NINE MILE POINT NUCLEAR STATION

SUBJECT: Nine Mile Point Nuclear Station
Unit No. 2, Docket No. 50-410

License Amendment Request Pursuant to 10 CFR 50.90: Request for Adoption of
Technical Specification Task Force Traveler TSTF-514, Revision 3, "Revise BWR
Operability Requirements and Actions for RCS Leakage Instrumentation"

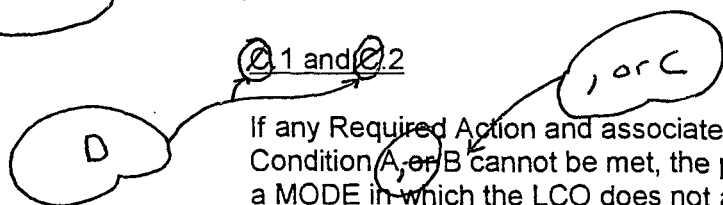
B.1 and B.2

With both gaseous and particulate drywell atmospheric monitoring channels inoperable (i.e., the required drywell atmospheric monitoring system), grab samples of the drywell atmosphere shall be taken and analyzed to provide periodic leakage information. Provided a sample is obtained and
